Alaska Railroad Corporation
327 W. Ship Creek Ave.
Anchorage, AK 99501

Addendum 1
ITB #22-37-209901
ARRC Passenger Coach Repainting and Repair

Addendum number 1 has been issued for questions/ clarification.

TITLE: **ARR 301 PAINT AND REPAIRS ELEVATION VIEWS**

A
1 ARR 301 LEFT SIDE ELEVATION
SCALE: NTS

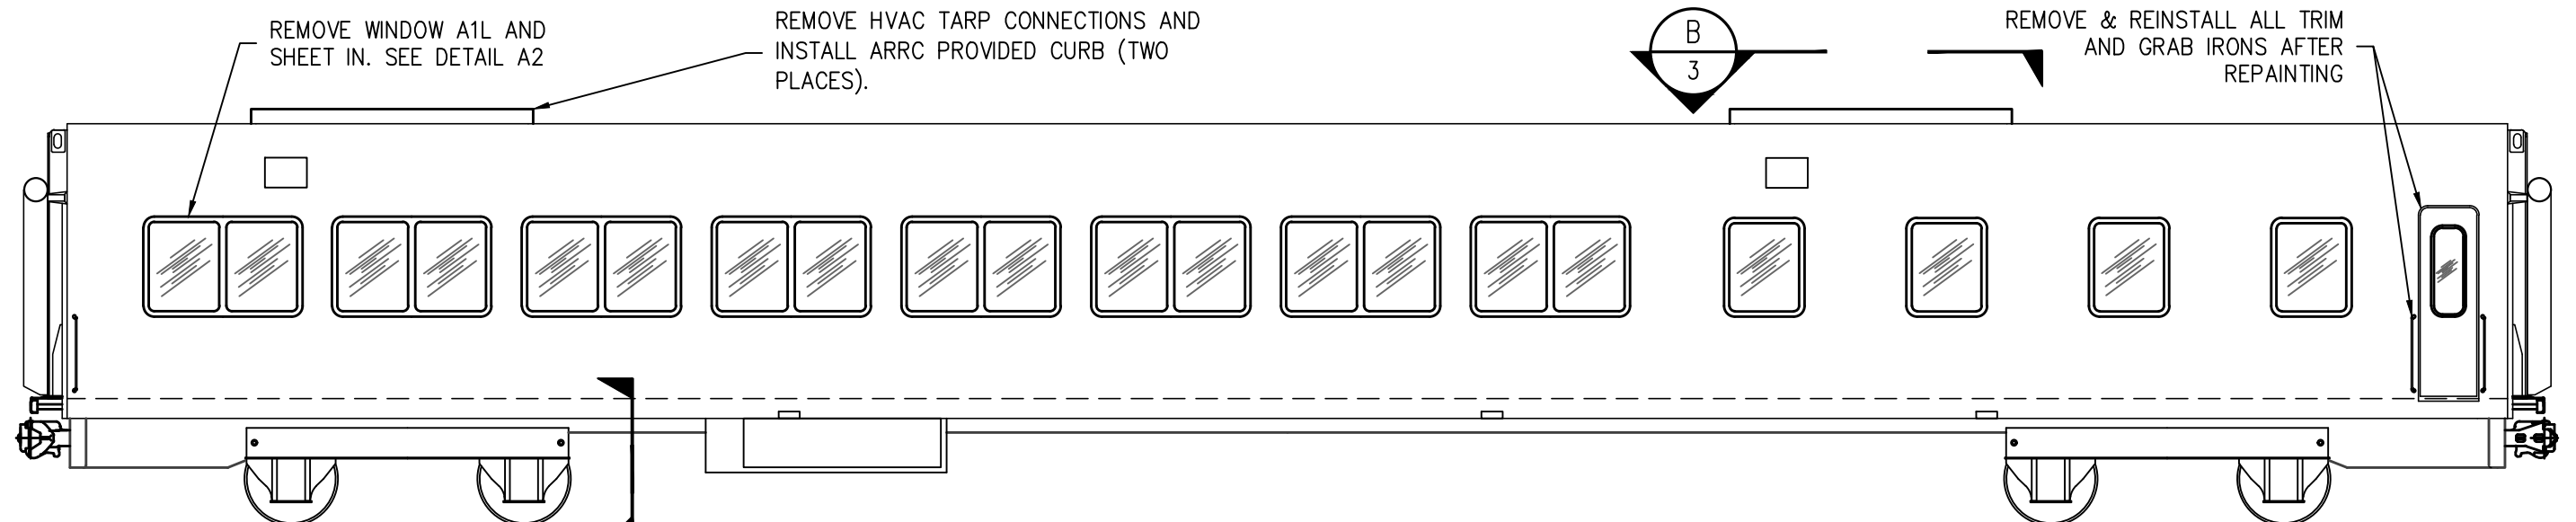
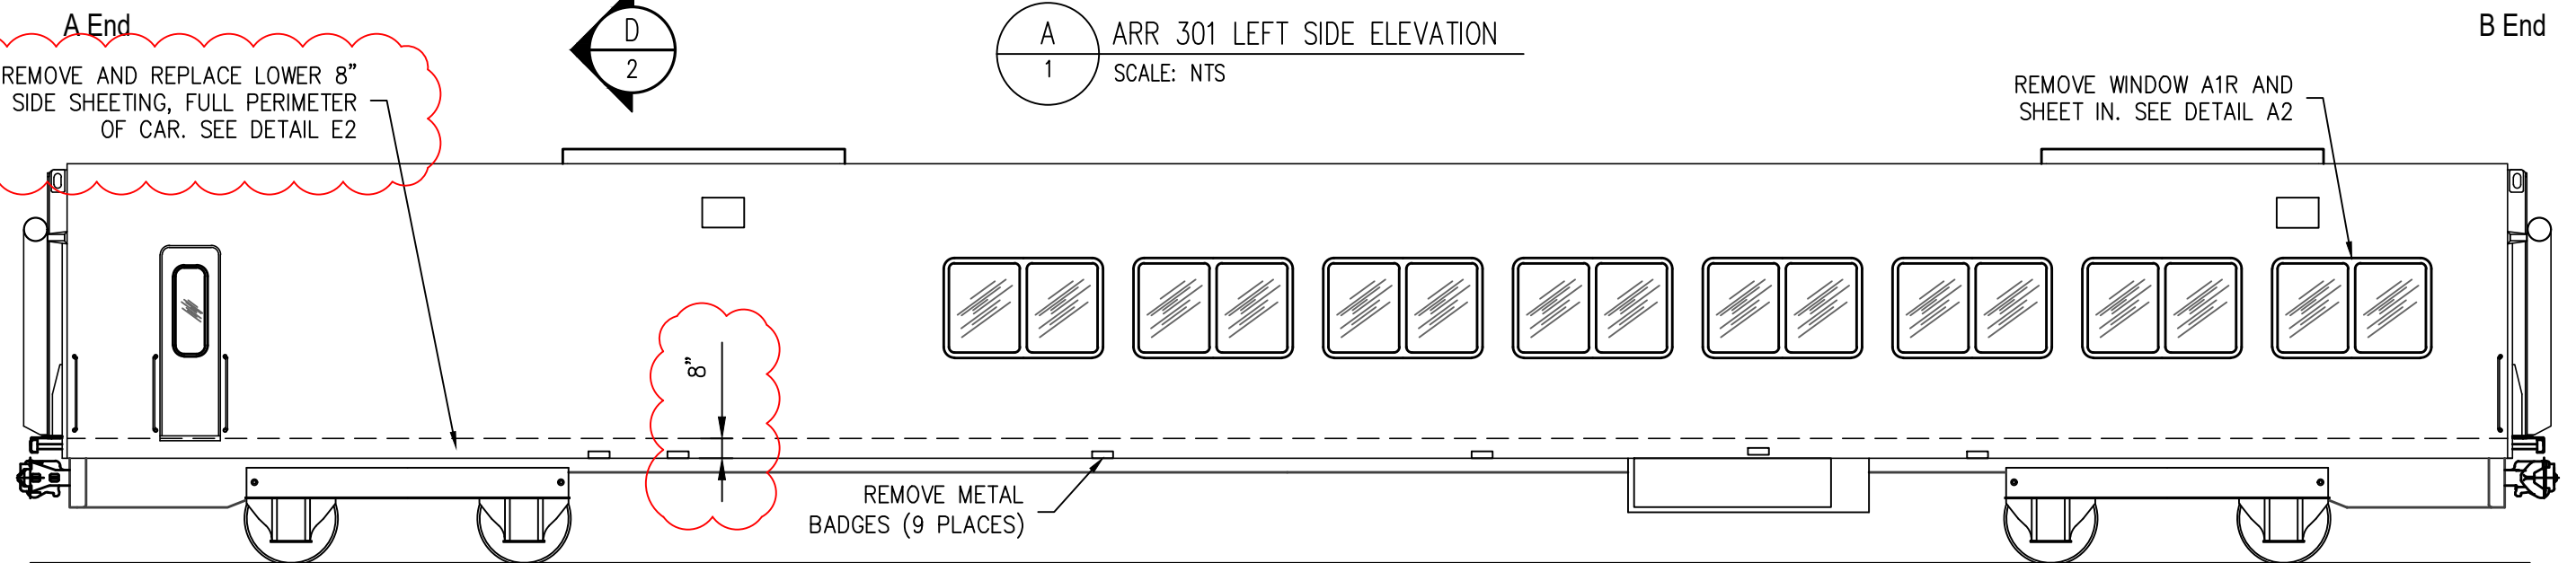
REMOVE AND REPLACE LOWER 8" OF SIDE SHEETING, FULL PERIMETER OF CAR. SEE DETAIL E2

E
2
SIDE SILL SECTION; EXISTING & REPLACEMENT
SCALE: NTS

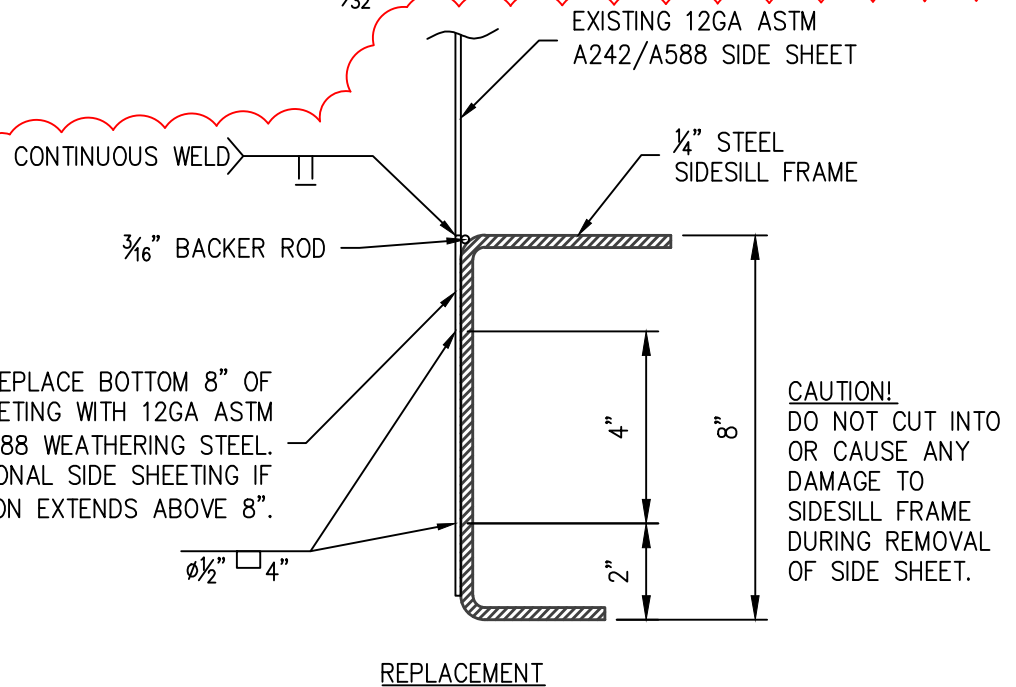
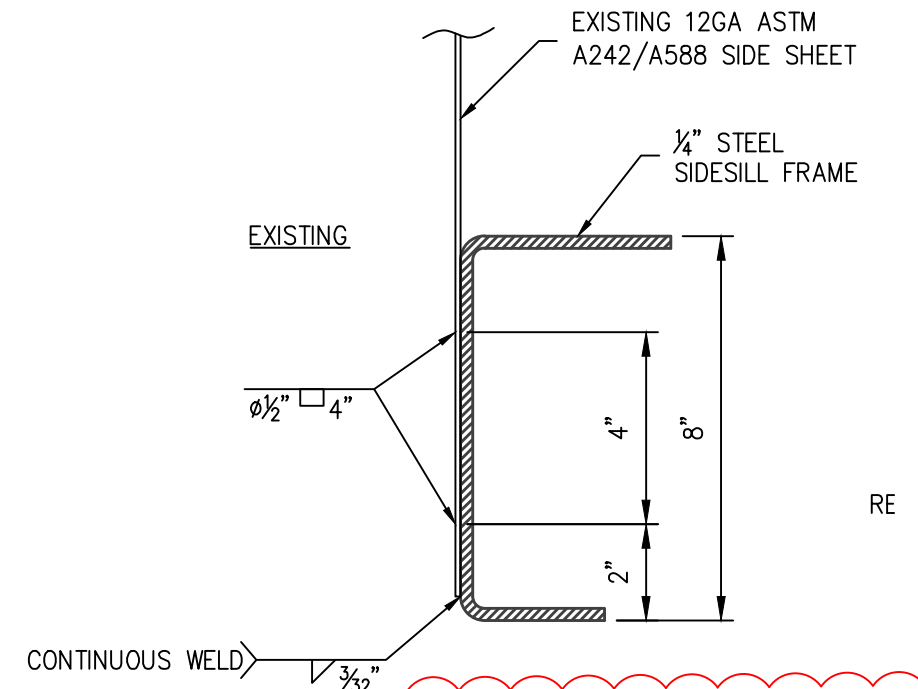
1. Change repair of side sheeting to remove and replace lower **8"** of sheeting to fully remove corrosion.
2. Change replacement weld method to two plug welds @ 4" spacing instead of continuous lower fillet weld.

REMOVE & REPLACE BOTTOM 8" OF SIDE SHEETING WITH 12GA ASTM A242/A588 WEATHERING STEEL. REMOVE ADDITIONAL SIDE SHEETING IF CORROSION EXTENDS ABOVE 8".

3. Mirror side sill supports on opposite side of coach to maintain lateral car balance.
4. Cut and remove lower 4" 8" of side sheeting, both sides of car, in lengths not exceeding twenty (20) feet.

6. If corrosion is found above the location of cut, remove additional side sheet ~~up to 7"~~ **as required** above lower edge of sidesill frame.
7. Coat all exposed **side sill &** inner structure with organic zinc primer (Dimetcote or approved equal).

8. Replace side sheeting with 12ga ASTM A242/A588 (weathering steel). New sheeting to be continuously groove welded to existing side sheeting at top and ~~filet~~-**plug** welded to side sill structure ~~at bottom~~ as indicated in Attachment A.
